PROJECT #: **PP-SPR-26-0011**

RE: Notice of Decision - Site Plan Review (Project No. PP-SPR-26-0011)

The plans for the construction of a 504 square foot detached garage conversion Accessory Dwelling Unit (ADU) in the R-3 (Medium Density Multi-Unit Dwelling) zone district located at 1307 Tulare Street have been reviewed by the Site Plan Review Committee. The proposal meets the minimum required codes, policies, and standards for development as adopted by the Bakersfield City Council.

ACCESSORY DWELLING UNIT

SITE PLAN

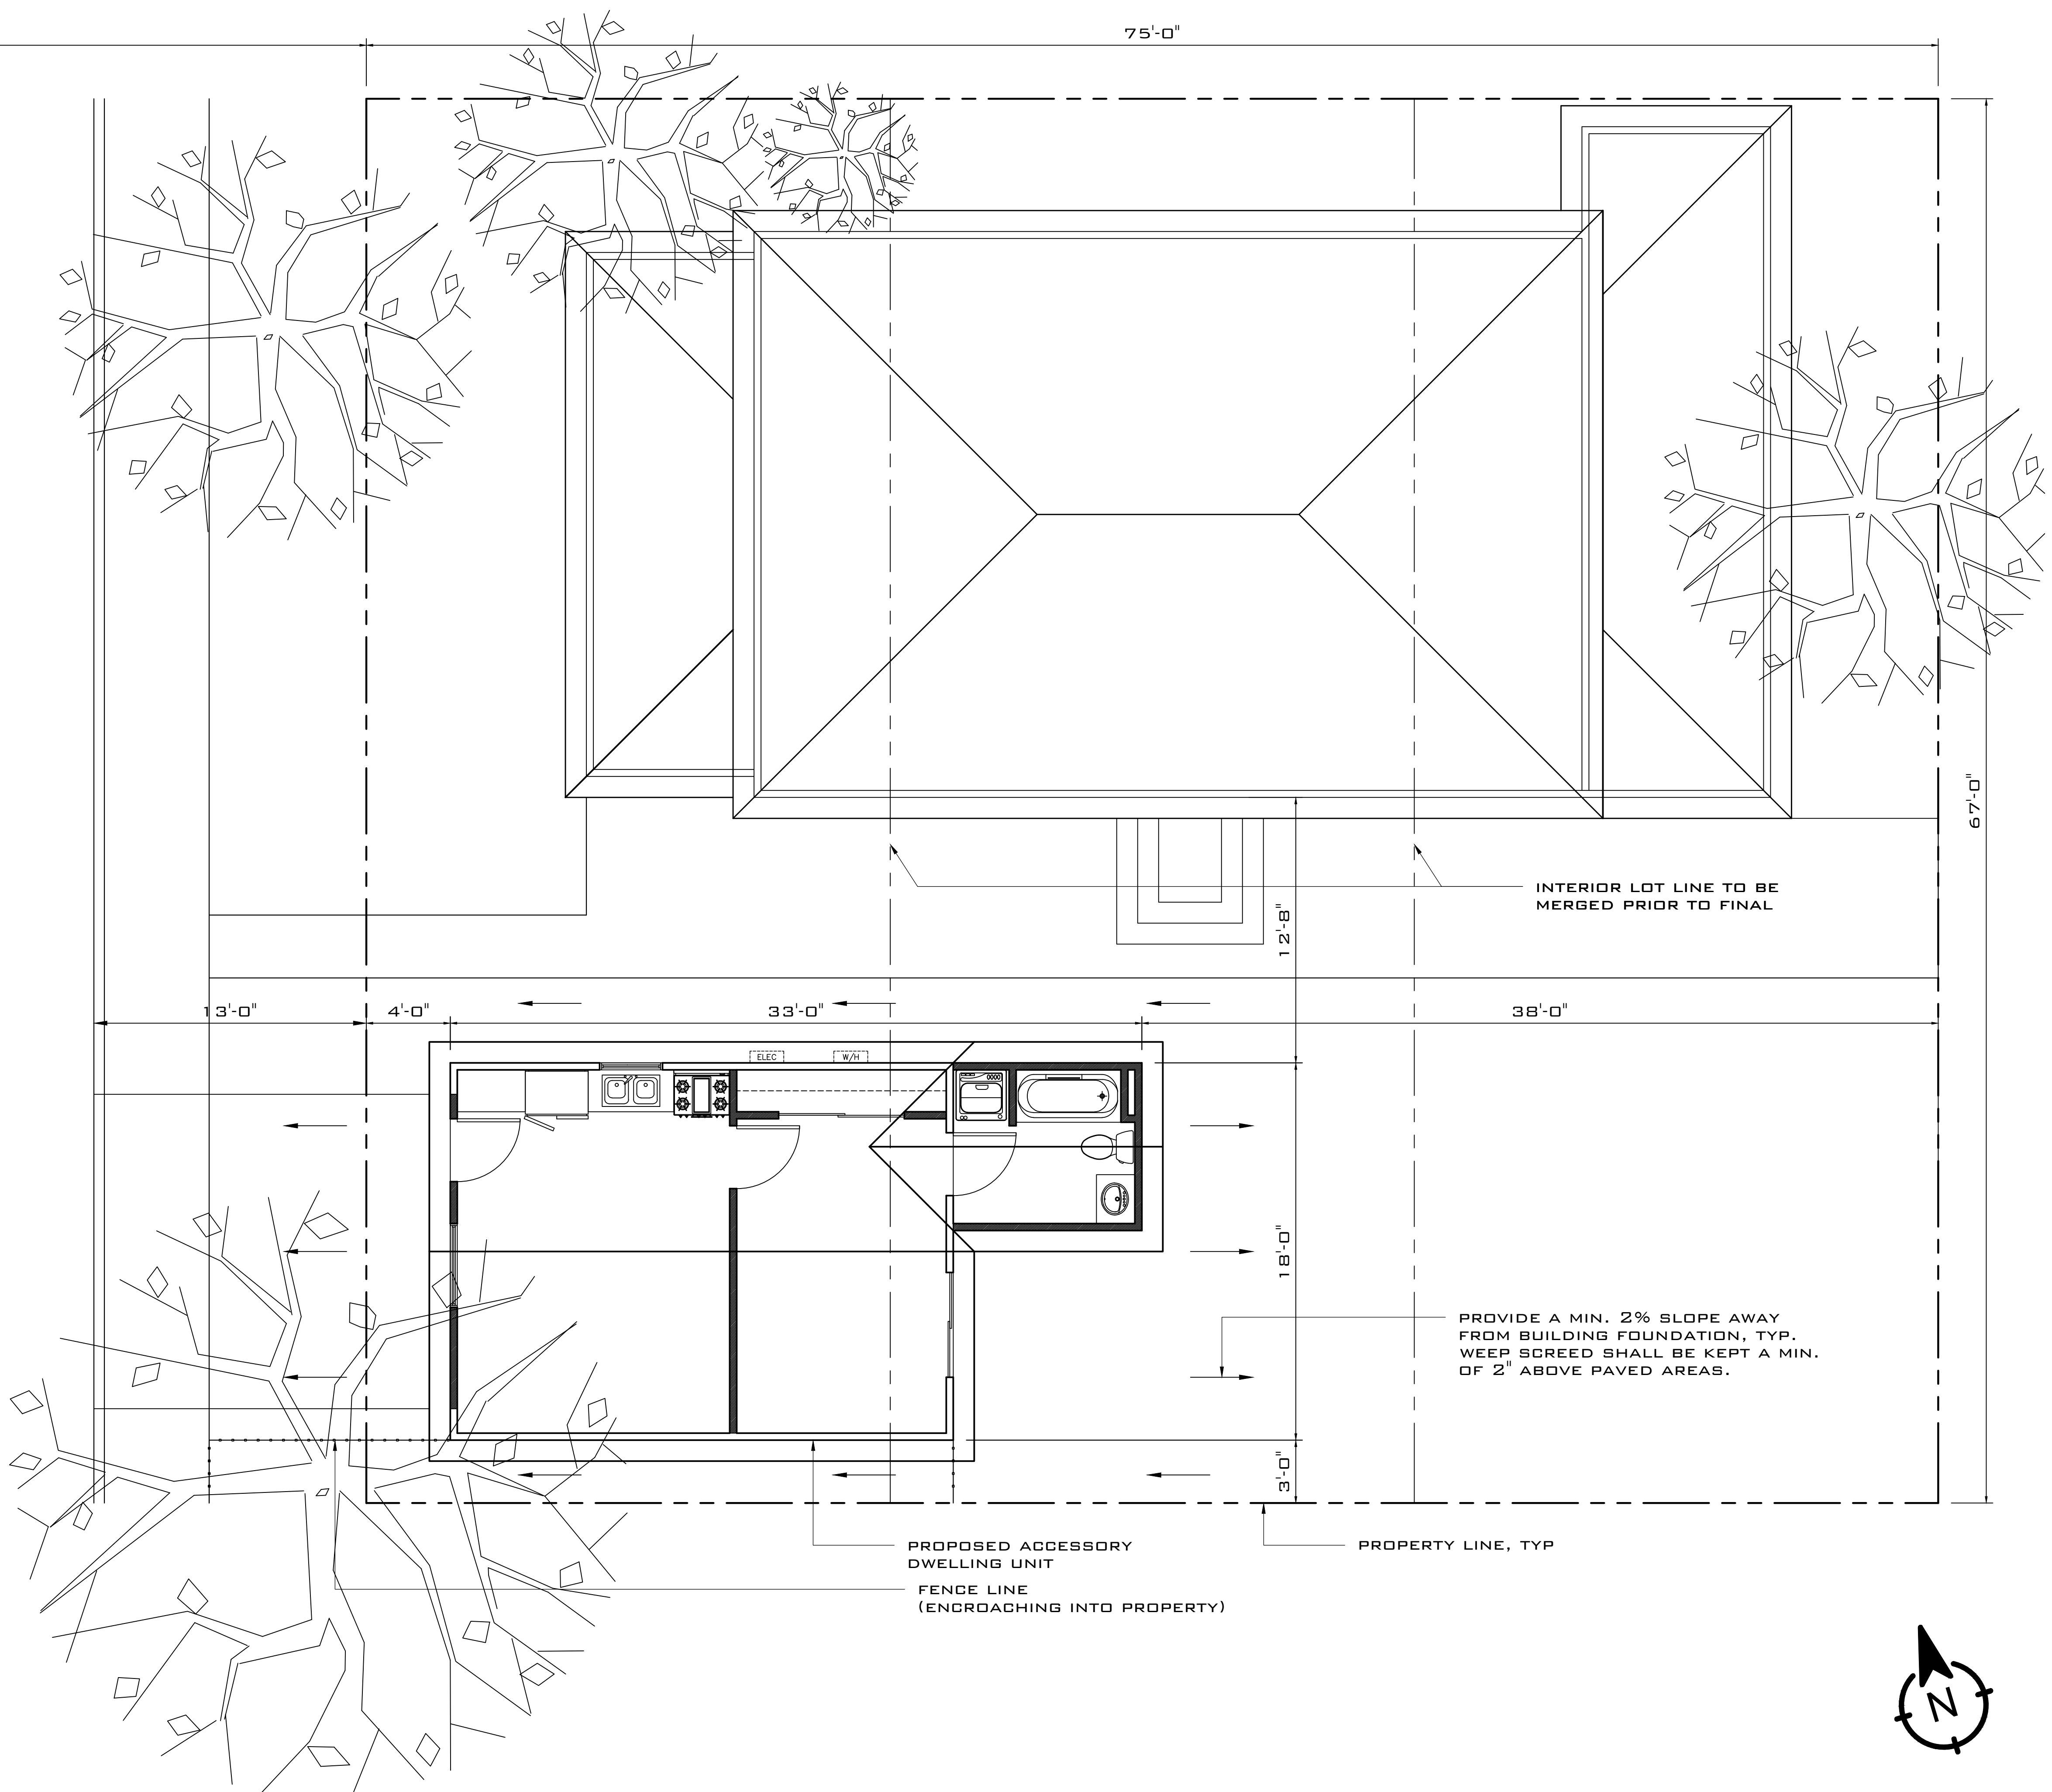
1. City records show the project is contained in more than one parcel. Because building setbacks cannot be met based on the design layout, a parcel line bisects a building, and/or parking for residential use is not on the same site as the project, a parcel merger or lot line adjustment application removing or relocating property lines shall be submitted to the Planning Division. Recordation of the land division action shall occur before final building or site occupancy can be granted. If City records are in error, provide documents showing compliance (contact: Planning Division; 661-326-3733).

INTERIOR LOT LINE TO BE MERGED PRIOR TO FINAL
